SIB 52 19 19

SECOND ROW 60/40 PASSENGERS SIDE SEAT INTERMITTENTLY
WON'T LATCH

2019-08-05

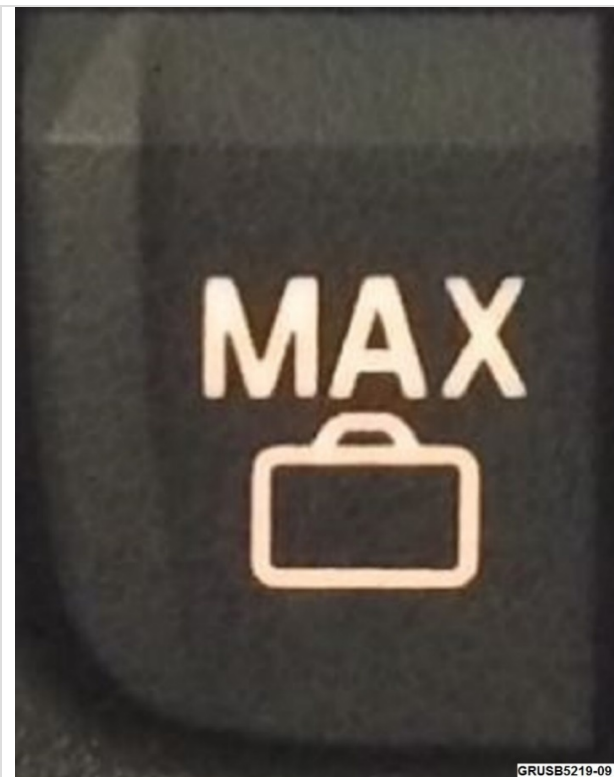
Manufacturing tolerances of the seat assembly produced between mid-July (Calendar week 26) and early October (CW40) of 2019.

- A seat frame production change was made in CW26
- A single washer is planned to be installed on the inner rail of the passenger second row seat in CW 40

As of CW40 production, one machined washer (shown) will be added to the bottom of the inner seat rail on the passenger's side (right rear) of the 60/40 split 2nd row seat.

For vehicles with this specific complaint that were produced from June 24, 2019 thru October 1, 2019, a comparable correction is to add a single 2mm thick flat washer in this location.

The washer must have-

- 15mm inner diameter hole for the bolt fitment
- Outside diameter must be at least 30mm

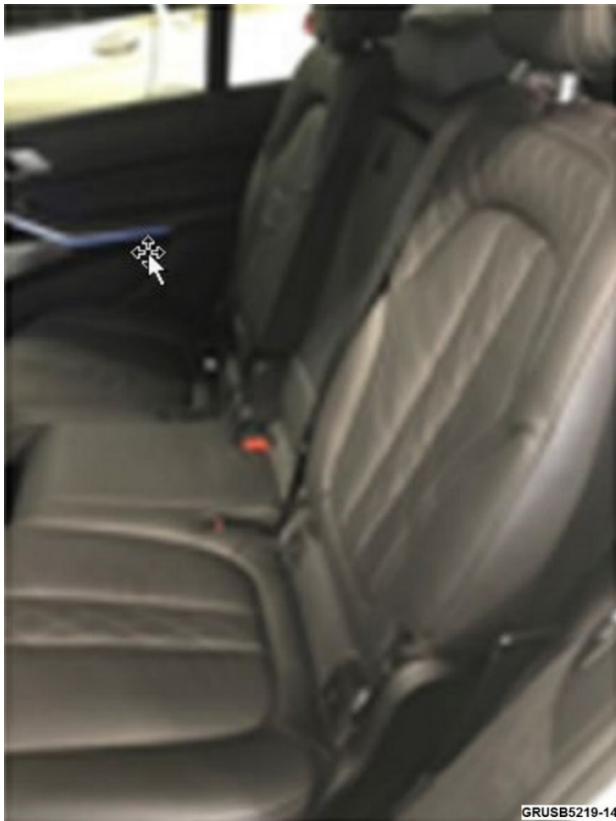
6. Install 1 flat 2 mm thick washer under rear of inner rail of the 40% structure.

Washer is installed between the floor of vehicle and the rear of the inner seat rail.

- Only install a washer at the specified location.
- The 60% seat is not affected by this repair.

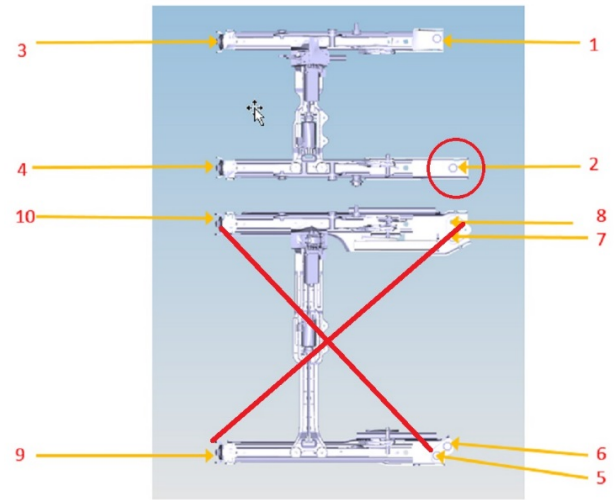
10. Move the seat only as far forward as necessary to reach the rear inner rail and fasteners.
- Seat must ***NOT*** be in easy entry position during the fastener torquing.
 - Seat must ***NOT*** be fully forward when torquing the fasteners

Note: Only install the 1 washer at the specified location 2 (circled).

- Locations 5 thru 10 pertain to the 60% 2nd row seat which is not affected by this repair.

11. Tighten all fasteners to 42Nm following the torque sequences #1 thru 4.
